Project: LYNEHAM COMMUNITY ACTIVITY CENTRE AND SPORTS PAVILION CARPARK. Date: 13/10/14

Drawing Title: TREE AND VERGE MANAGEMENT PLAN - 2 OF 2. Drg. No. RG 13039, Sheet 110, Revision 0

Project Title:  
**PROPOSED NEW SPORTS PAVILLION**  
Address:  
BRIGALOW STREET LYNEHAM  
Unit      Block      Section      Division  
                 23            41            LYNEHAM

**From:** EPD, Customer Services  
**Sent:** Monday, 27 October 2014 12:00 PM  
**To:** TAMS CIS ASG DA  
**Subject:** REFERRAL-TAMS-STORMWATER/WASTE & TRAFFIC MGMT/URBAN  
TREESCAPES-201426427-23/41-LYNEHAM-01  
**Attachments:** plans.obr; supporting docs.obr

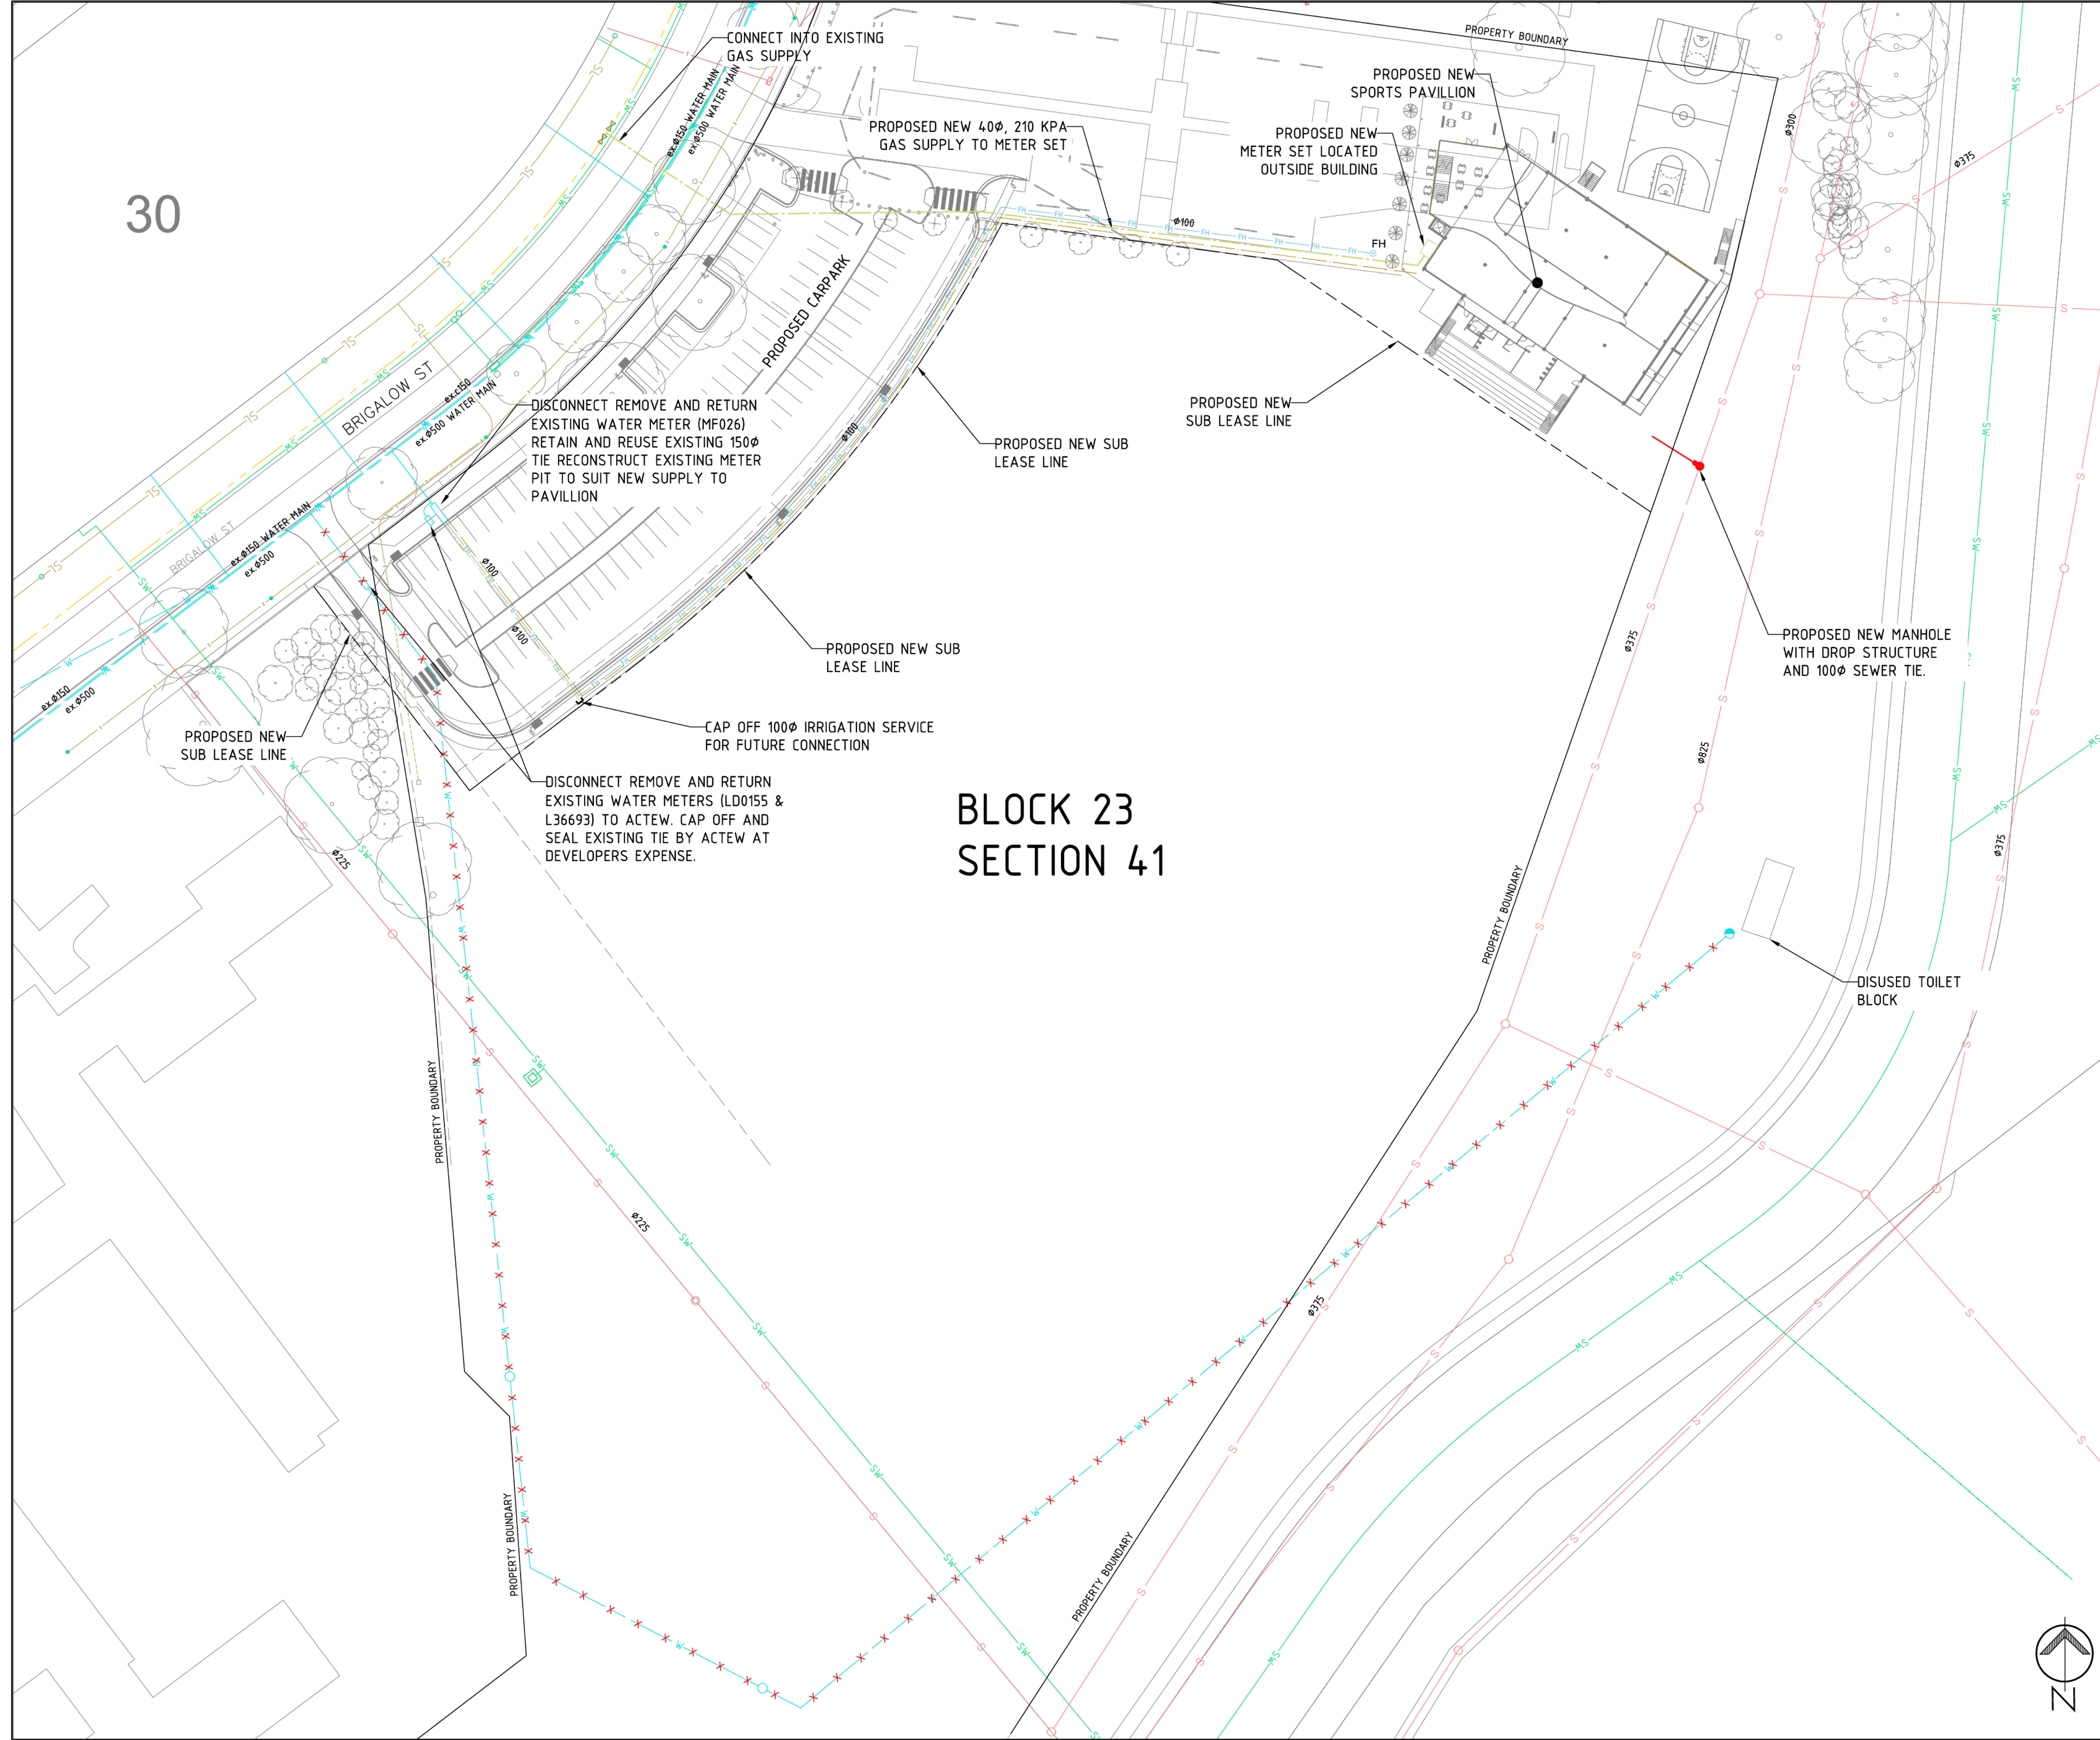
canopies, to ensure effective tree protection measures are incorporated in the design and implementation of the project. (The current 'Tree and Verge Management Plan' (Dwg # RG 13039 Rev0) does not adequately cover the necessary tree protection measures required for the type of proposed work that could impact on the trees.)

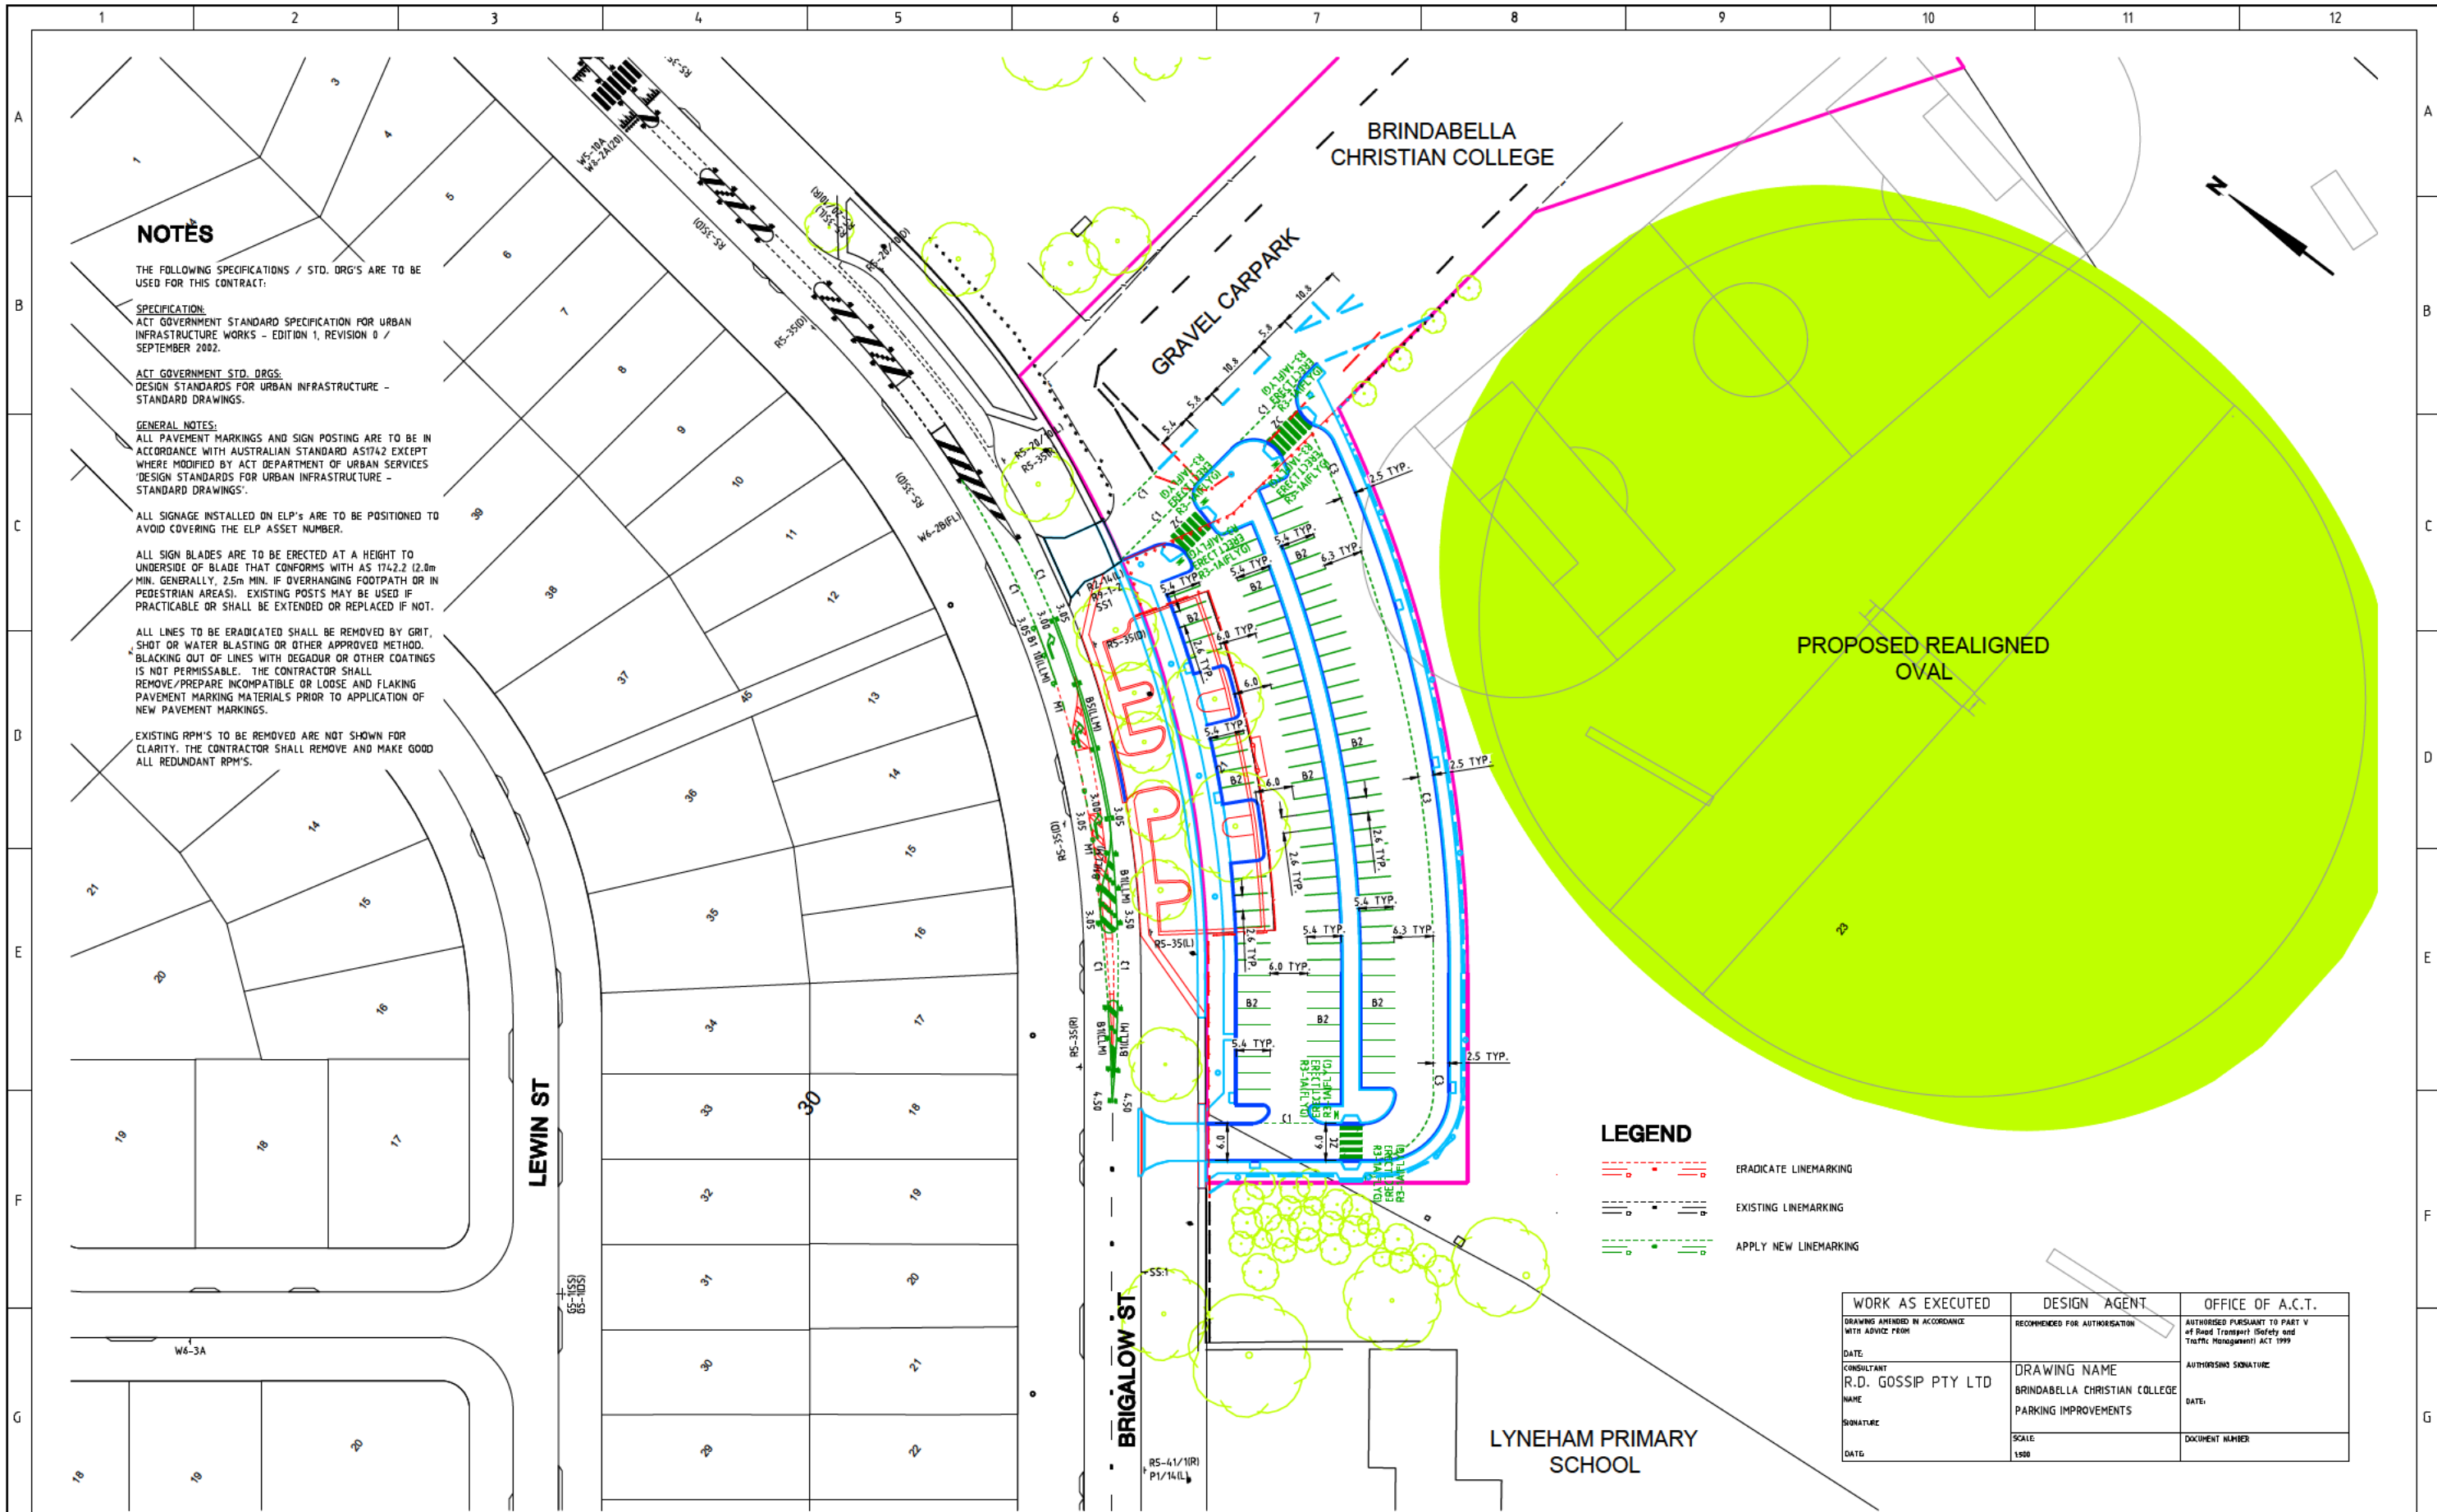
The Sullivans Creek trunk community path runs right past the pavilion site, yet no footpath connection to it is shown. It could be expected that the majority of people walking, riding a bike, or using public transport to access the facility will approach from this trunk path rather than from Brigalow Street. Two paths would be needed to cater for natural desire lines from both north and south, as shown on the attached site plan.

An enormous new carpark forms part of this application, but not a single bike rack is evident on the plans.

TAMS design standards for new footpaths would indicate a minimum footpath width of 1.5 metres is required for the new section of footpath proposed along Brigalow Street, however the plans show the new path the same width as the very narrow existing path. It seems poor practice to perpetuate the inadequate standards of the past with new construction that is non-compliant with modern standards.
